BOARD ACTION REPORT – APPEALABLE ITEM

Project Name: Congress Warehouse
Project Location: 355 North Congress Avenue
Request: Class V Site Plan, Landscape Plan, Architectural Elevations and Waiver

SITE PLAN REVIEW AND APPEARANCE BOARD

---STAFF REPORT---

DRAWN	R.E.T
CHECKED	G.J.C.
DATE	03/12/15
SCALE	AS NOTED
JOB, NO.	15-014
SHEET	A-0
OF	SHEET

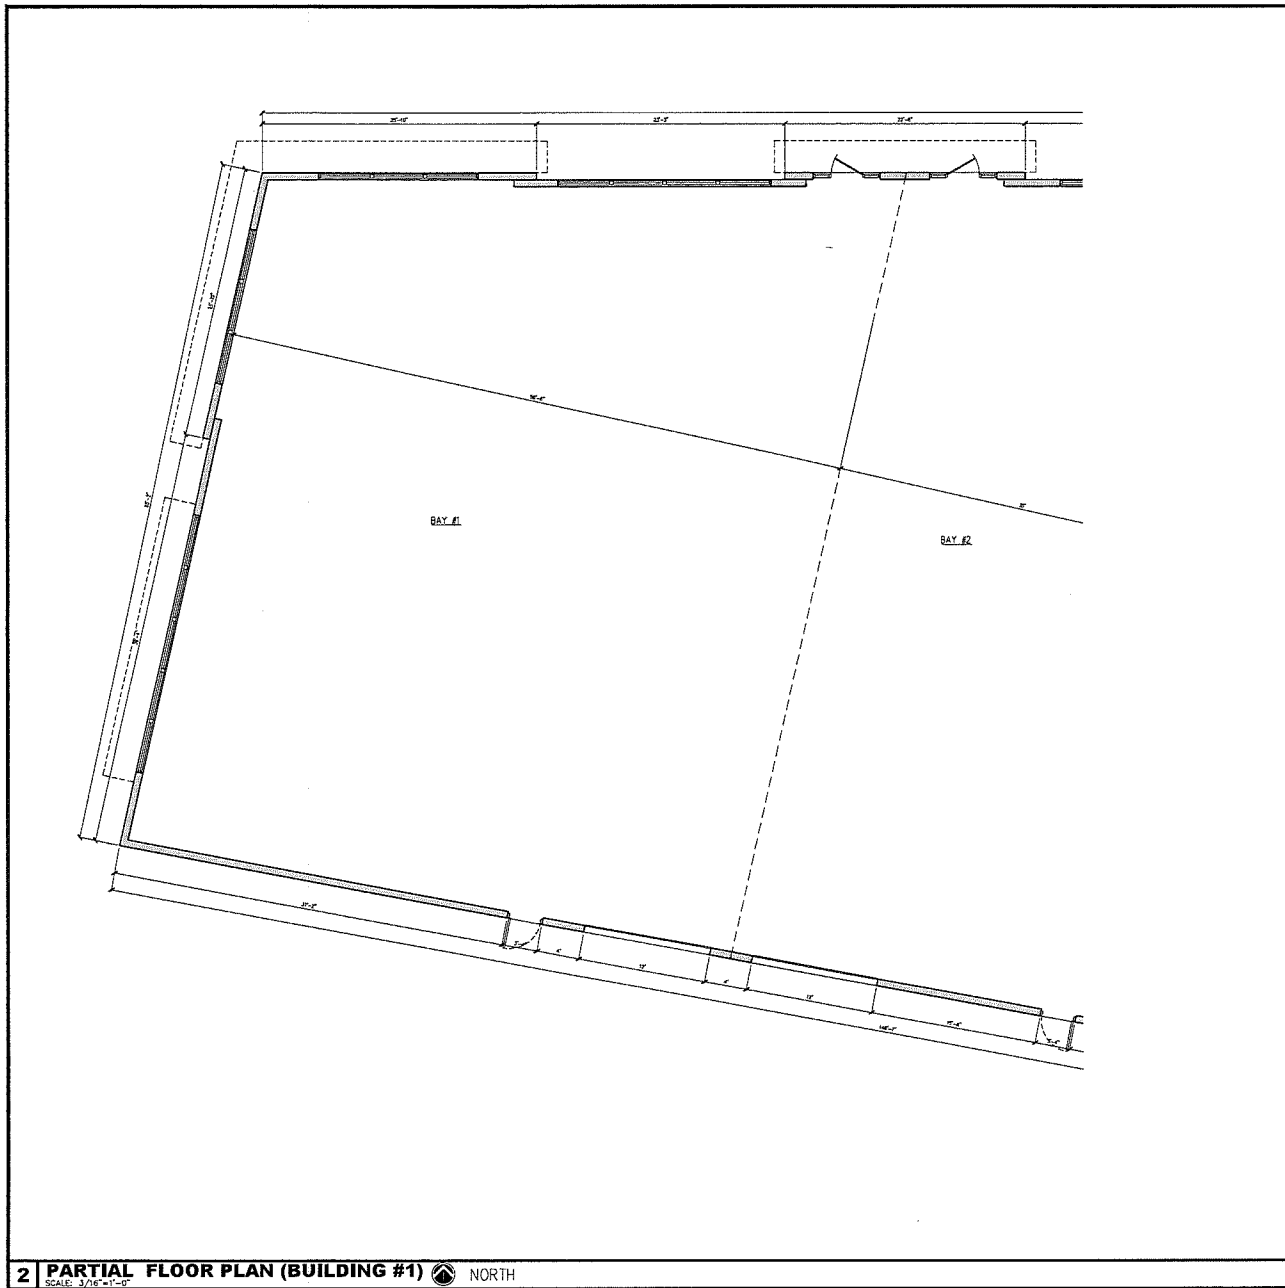
1. The floor plan details are inconsistent throughout the plan set (i.e. 5 bays vs. 3 bays). Only the building footprint is required on plans other than the actual floor plan sheets (A-0 and A-2). Either remove the floor plan details from *all other sheets* or make them consistent with current proposal (i.e. 3 bays).

1. The floor plan details are inconsistent throughout the plan set (i.e. 5 bays vs. 3 bays). Only the building footprint is required on plans other than the actual floor plan sheets (A-0 and A-2). Either remove the floor plan details from all other sheets or make them consistent with current proposal (i.e. 3 bays).
2. Obtain written consent from the abutting property to south for the proposed cross access into their site. If legal documents existing supporting this connection, provide a copy for the file and denote the plat book and page number reference on the plans. Otherwise, this connection must be removed.

2 SOUTH BUILDING ELEVATION (BUILDING #1)
SCALE: 1/8" = 1'-0"

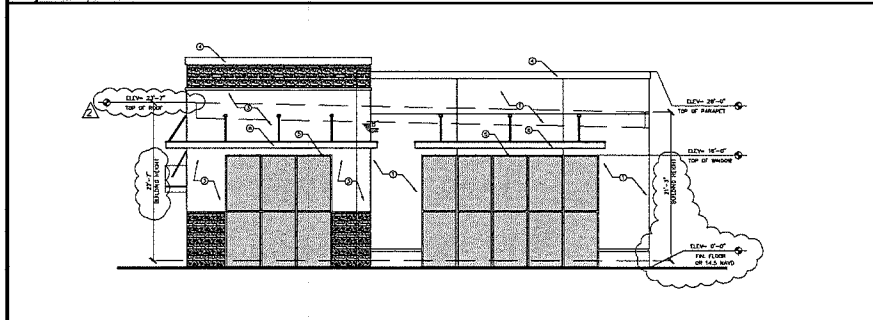
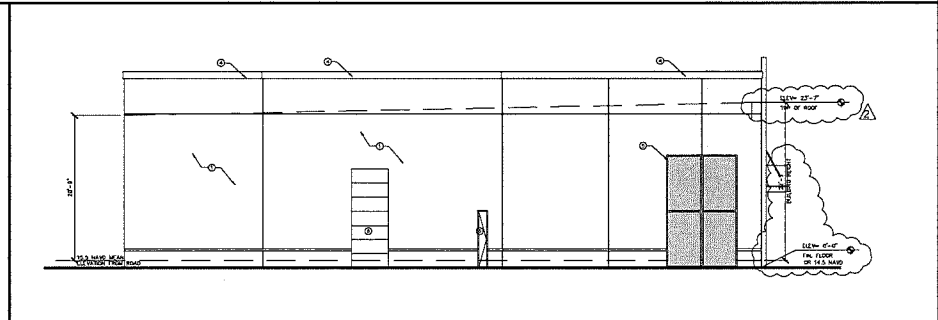
While the elevations are superior in design, style and materials, the focus appears to be only on the elevations specifically fronting along North Congress Avenue. At a minimum, staff recommends that some banding at the top and bottom of the other elevations be added to match either the "Outgoing Orange" or "Coastal Plain" color for both Building #1 and Building #2. This is recommended as a condition of approval. Also, the color chips must be updated to reflect the proposed Sherwin Williams colors, not Benjamin Moore. Similarly, the manufacturer pamphlet for the stone veneer and metal awning must be added to the file.

1. Add color banding at the top and bottom of the south and east elevations to match either the "Outgoing Orange" or "Coastal Plain" color for both Building #1 and Building #2. Also, add color banding to the north elevation of Building #2 for consistency. Optional color banding can wrap around the west elevation of Building #1 to match.
2. Replace the color chips with the proposed Sherwin Williams colors, not Benjamin Moore. Provide the manufacturer pamphlet for the stone veneer and metal awning.
